Technical change to 1856120000 + 2622370000

the product 1856120000 (SAIE-M12S-5-0.5U-PG9) + 2622370000 (SAIE-M12S-5-1.0U-PG9) will be changed after a transitional period.

2. Change details

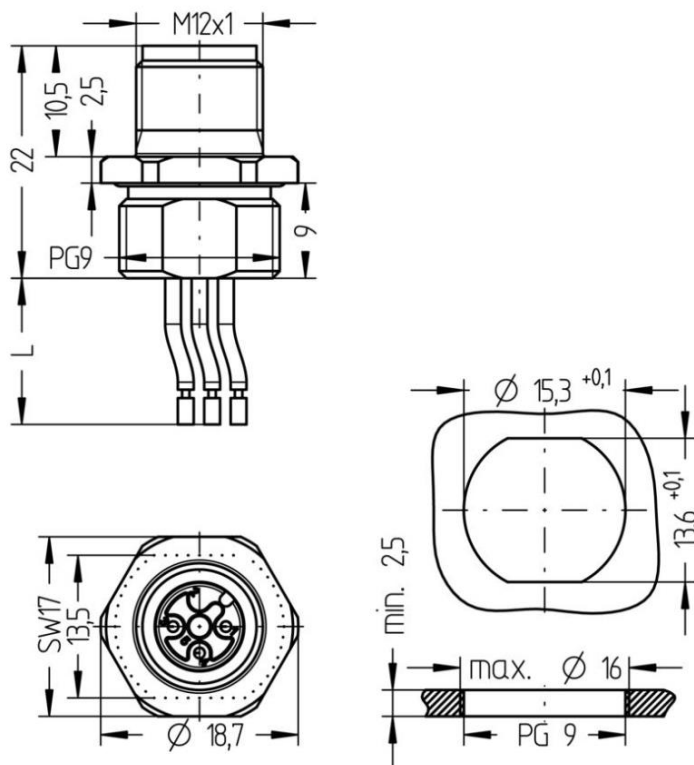
- Change to lead-free

1856120000 + 2622370000 Old:

1856120000 + 2622370000 New:
